# **MONITORING YEAR 1 ANNUAL REPORT**

## **CANDY CREEK MITIGATION SITE**

RE: Draft Monitoring Year 1 Report Comments  
Candy Creek Mitigation Site (DMS #96315)  
DMS Contract Number 5794  
RFP Number 16-005568  
Guilford County, NC

We have reviewed the comments on the Monitoring Year 1 Report for the above referenced project dated January 9, 2018 and have revised the report based on these comments. The revised digital files are submitted with this letter. Below are responses to each of your comments. For your convenience, the comments are reprinted with our response in italics.

Figure 3.2 Integrated Current Condition Plan View  
 Candy Creek Mitigation Site  
 DMS Project No. 96315  
 Monitoring Year 1 - 2017  
 Guilford County, NC

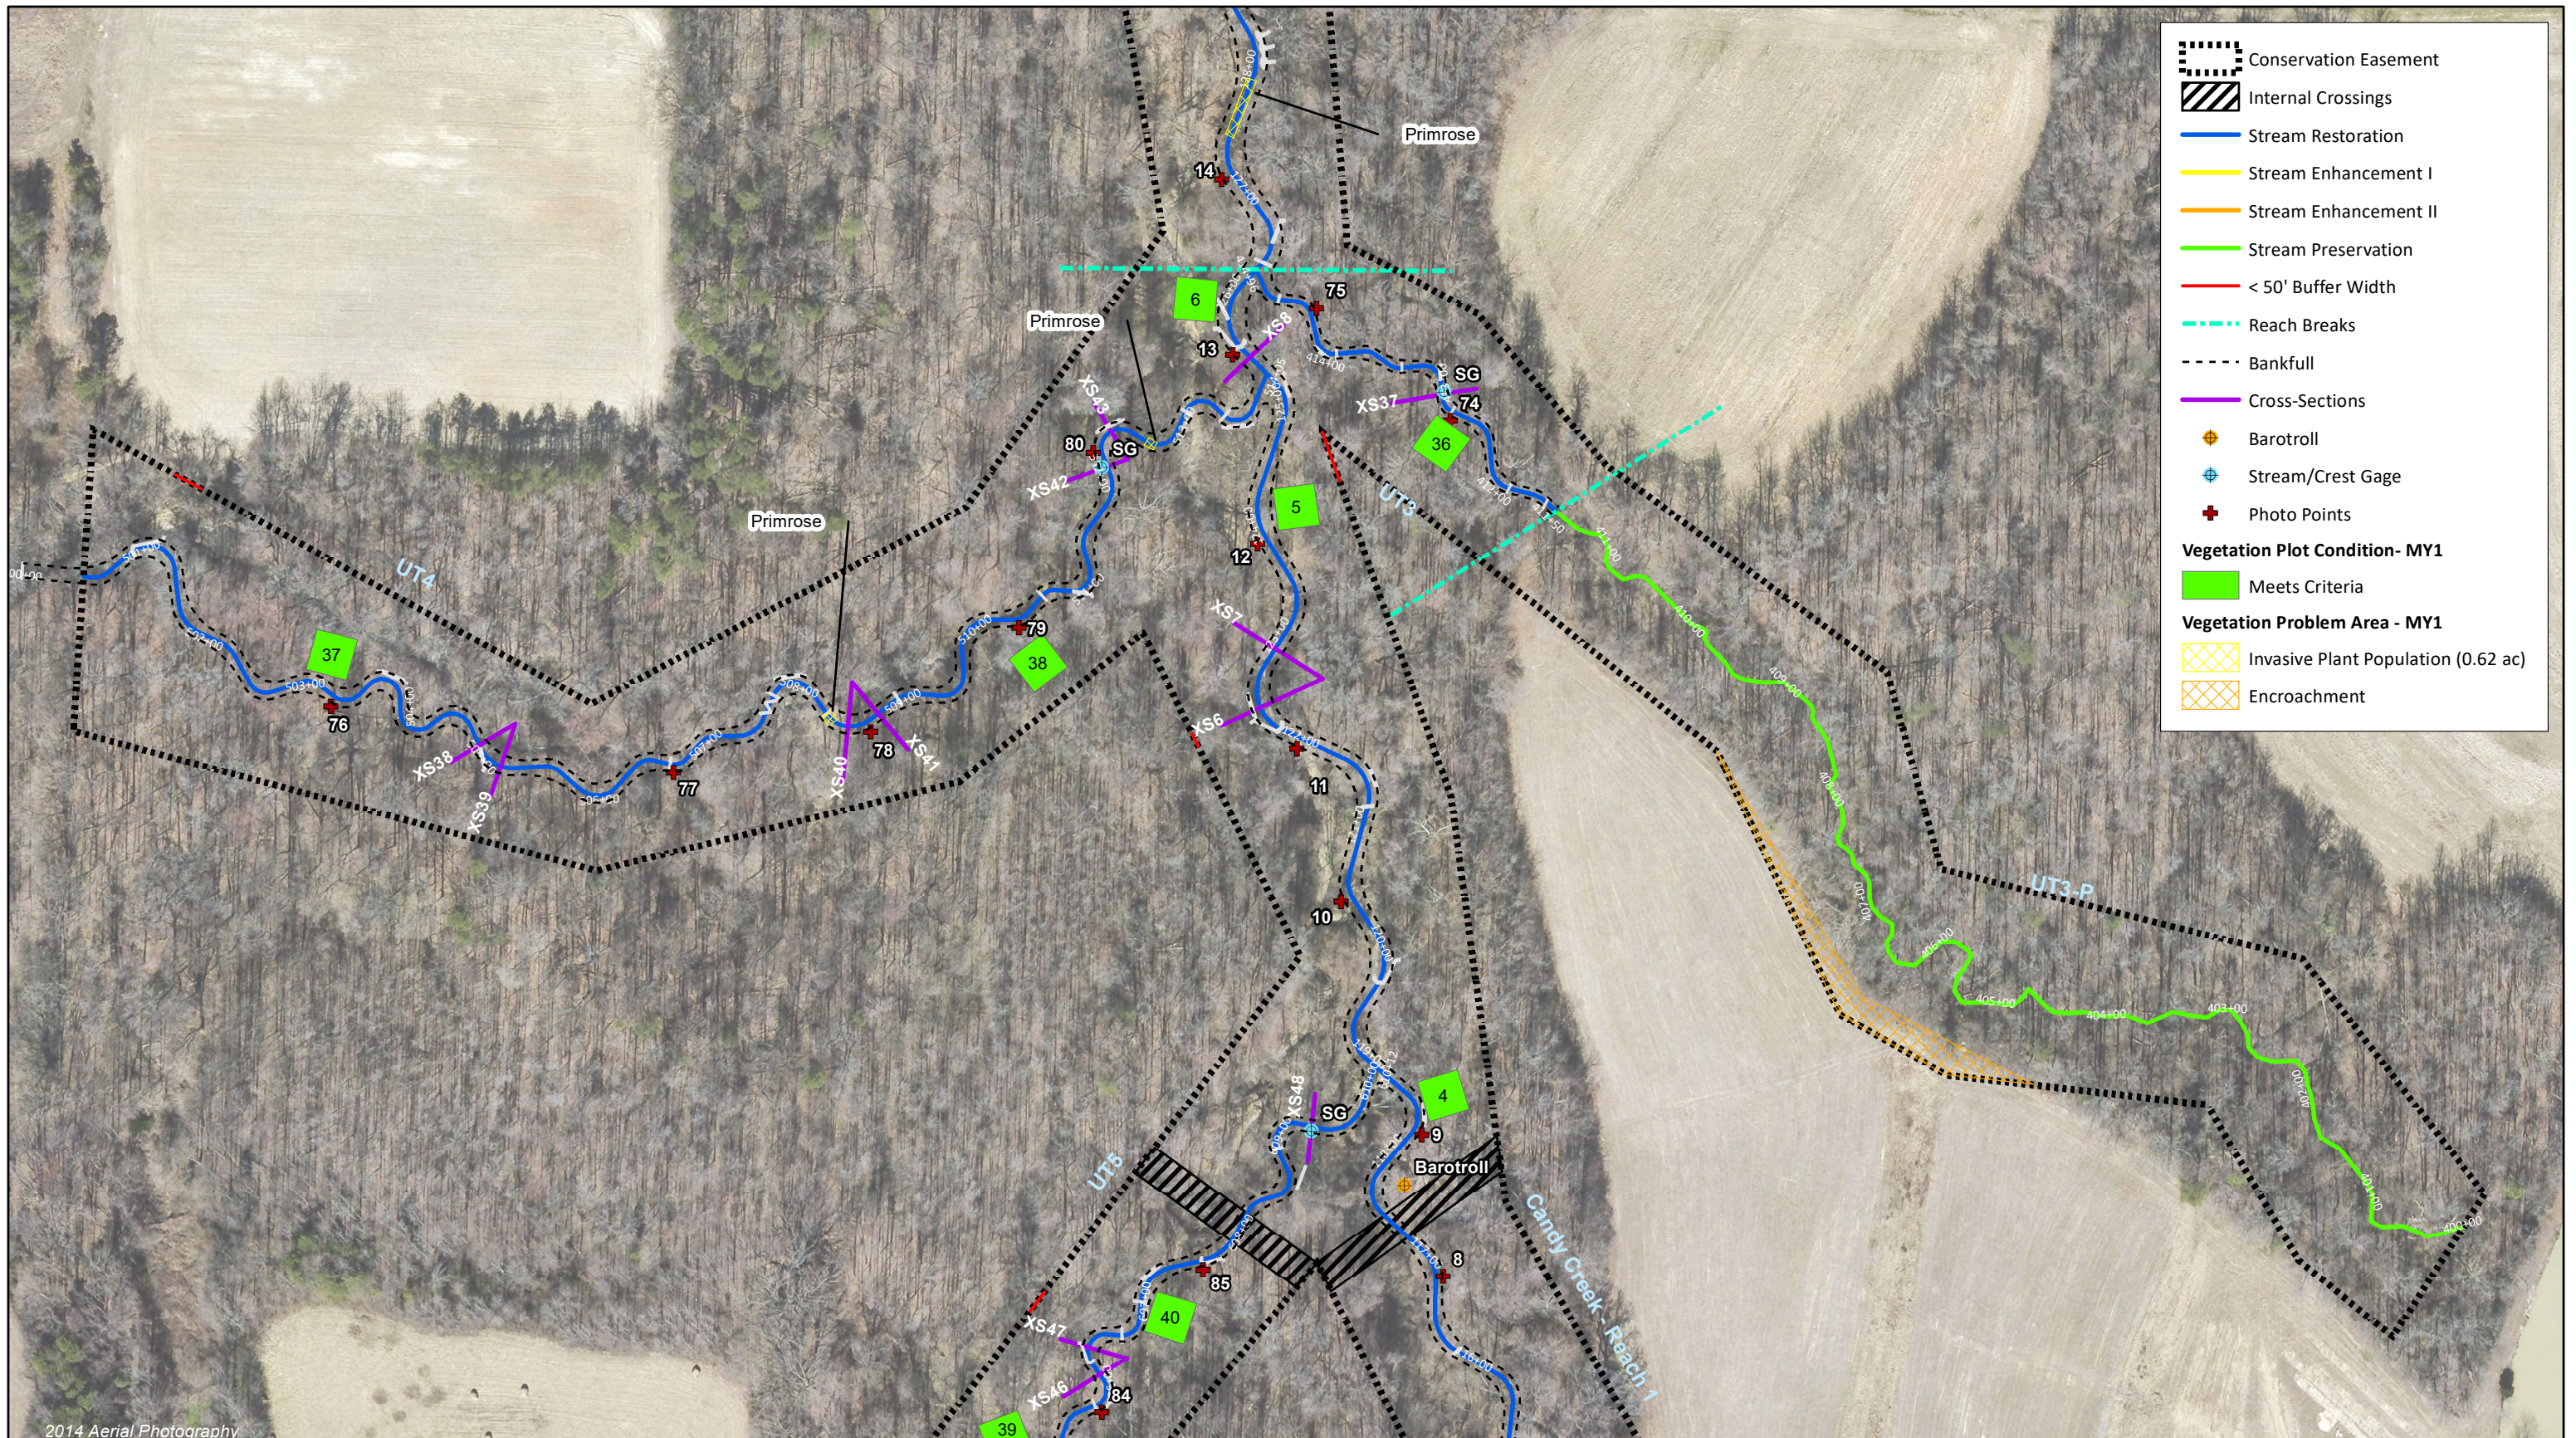
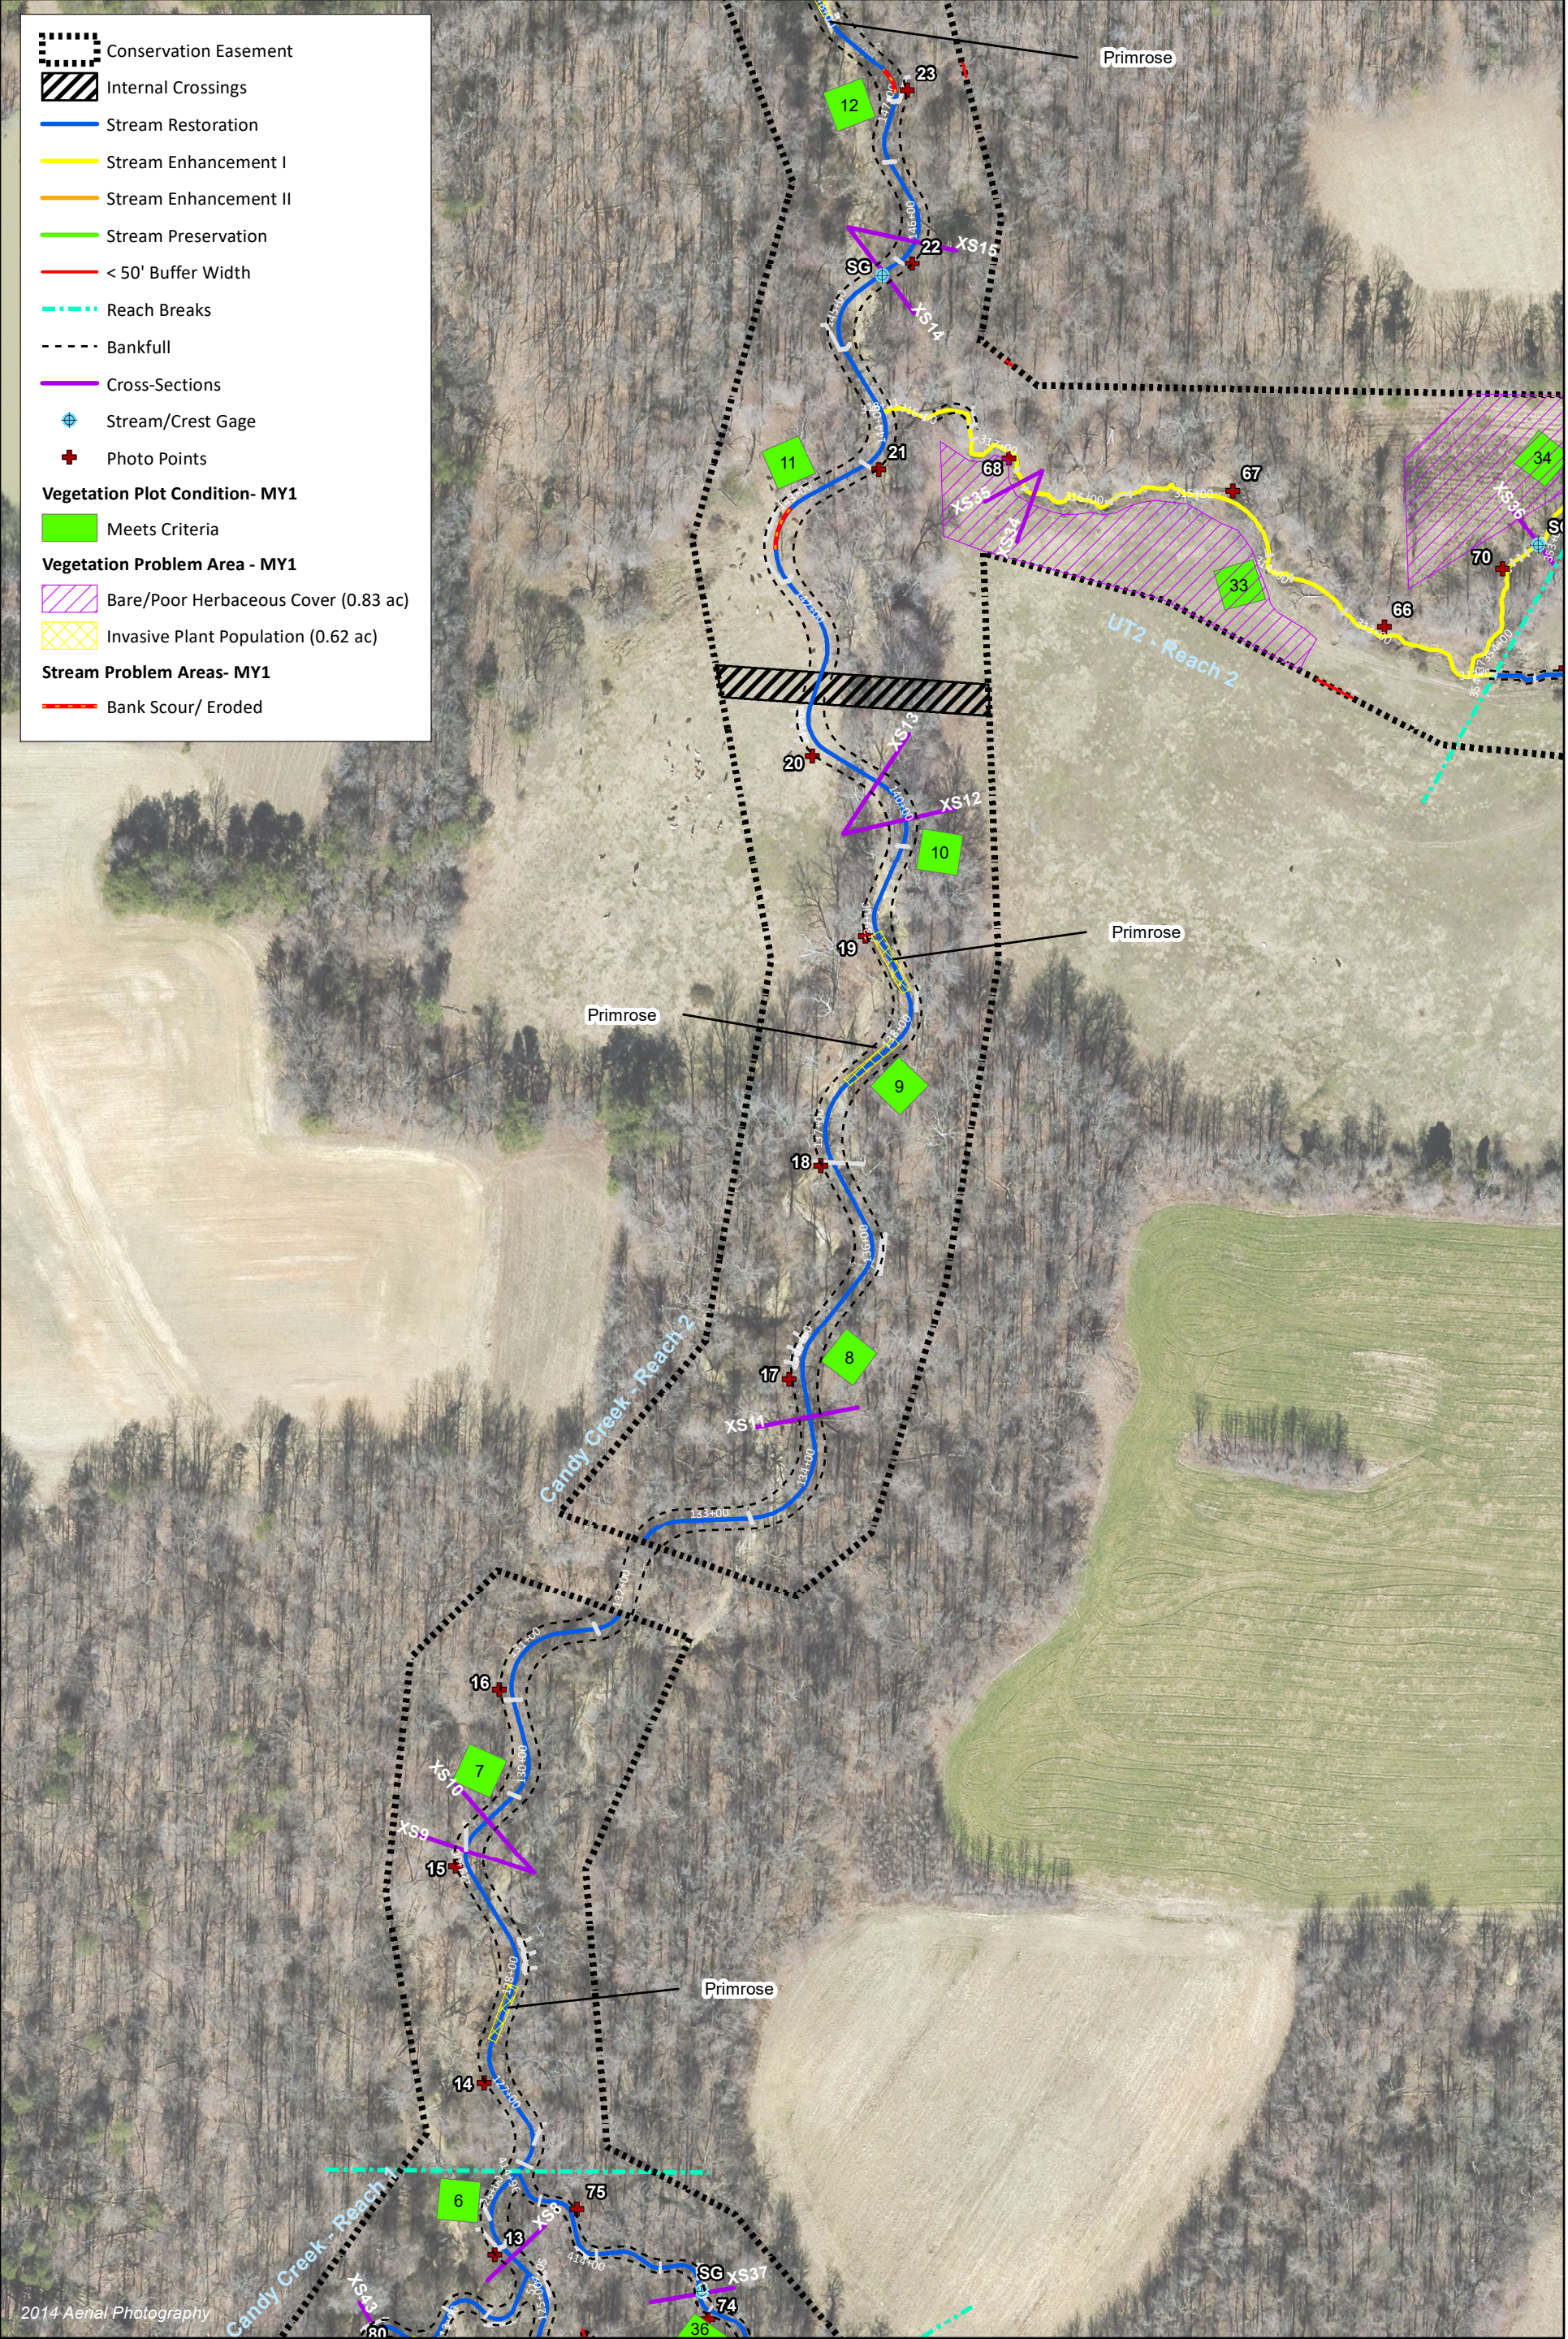
3. The CCPV shows sections along Candy Creek Reach 1, UT4, UT5, Candy Creek Reach 2, UT2 Reach 1, Candy Creek Reach 3, UT1C and Candy Creek Reach 4 where the buffer width is less than 50 feet. Wildlands addressed this in the As-Built Baseline report and indicated that the total length of these sections is approximately 3.1% of the total project length. Please address this in a sentence or two in the MY1 report and include that this is less than the 5% allowed by the IRT.

*An explanation was added to the end of the executive summary, page ii and section 1.2, page 1-2.*
